UNITED STATES ENVIRONMENTAL PROTECTION AGENCY

Re: Glades Reservoir Draft Environmental Impact Statement, Hall and White Counties, Georgia, CEQ# 20150300

Enclosure EPA's Detailed Comments on the Glades Reservoir DEIS CEQ No.: 20150300

Figure 1: From Richter 2011. Flows and Ecological Risk

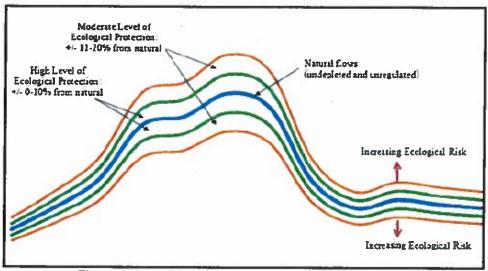
Once the low flow threshold is developed, additional studies could be conducted to determine other components of the flow regime that are protective. It should be noted that there is growing consensus in the ecological flow literature regarding the amount of disturbance that can be expected to cause impact to the aquatic community. For instance, the Percent-of-Flow (POF) approach "explicitly recognizes the importance of natural flow variability and sets protection

standards by using allowable departures from natural conditions, expressed as percentage alteration" (Richter et al. 2012). The POF approach is relatively simple to implement and may provide a high degree of protection for designated uses. A compilation and review of multiple studies (Richter et al. 2011) found that the expert results were "quite consistent" on the percent of deviation that provided protection for aquatic life. Specifically, that a moderate level of protection was maintained if flow deviated across the hydrograph by no more than 11-20%. A high level of protection was assumed with a 0-10% reduction (See Figure 1 below).

The EPA provides this as one example of an approach and welcomes the use of other scientific studies that could be used to develop recommended flows. However, it is important to ensure that the findings of the IFPT are consistent with relevant literature and the EPA is concerned that findings presented in the DEIS are not consistent.. For example, the conclusions presented in the TM resulted in flows that were 16% of the AADF for 8 months (154 out of 922 cfs) and 29.7% of the AADF for 4 months (276 cfs). That is, rather than preserving 80% of the flows as recommended by Richter's review, the recommendation for a significant amount of the year would be to preserve as little as 16% of the flows, removing over 80% of flows. In addition, instream studies specific to the Piedmont region of Georgia found that streams may "...begin to experience species losses if permitted withdrawal exceeds about 0.5 to one 7Q10-equivilent of water." (Freeman and Marcinek, 2006). If the A7Q10 is used for comparison in this case, those flows at which it would be expected to see species loss would be at 0.5 to 1 of approximately 156 cfs or removing 78 to 156 cfs. However, the range of flows projected to be removed using the recommended IFPT could be as high as 1,123 cfs (1,400 cfs - 277 cfs) during the month of March. The EPA is unaware of any studies that demonstrate protectiveness at these extreme levels. In addition, the recommended time increments for most studies are done to reflect daily, weekly, biweekly, or monthly variation. The TM does not articulate how a two-phased approach is protective or consistent with an ecological flow study.

Recommendation: The EPA recommends that the USACE consider in the FEIS that flows be developed more consistently with the scientific literature regarding both the flows selected and the time increments at which they apply.

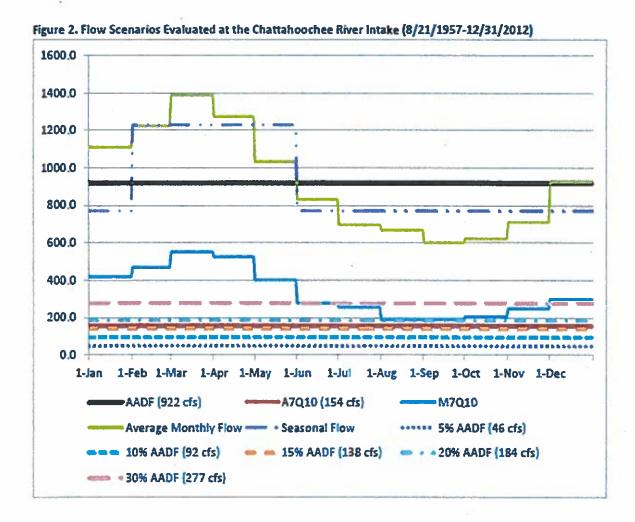
Sustainable Flows: The EPA is concerned that the results of the IFPT are presented as falling within the sustainable boundaries for flow protection, when they are not within those boundaries. The TM1 in Appendix O states that the "proposed pumping is estimated to reduce the AADF (922 cfs) by approximately 9% for the Applicant's proposed project." As stated above, the actual impact would be to alter flow by greater than 80%.

Recommendation: In order to most accurately represent the proposed change in flows, it is recommended that the Average Monthly Flow from Figure 2 of the TM1 be graphed together with the IFPT final recommended scenario represented in Figure 2 of TM2 (See above). This would allow the public, agencies and other stakeholders to discern the difference between the Average Monthly Flows and the proposed minimum flows. For instance, that would ensure that both graphs have the same values in the y-axis for easy comparison (currently Fig. 2.) Also, in that manner, one can see that during June the Average Monthly Flow would go from approximately 1,400 cfs to 277 cfs or that during December the Average Monthly Flow would go from approximately 922 cfs to the A7Q10 of 156 cfs.
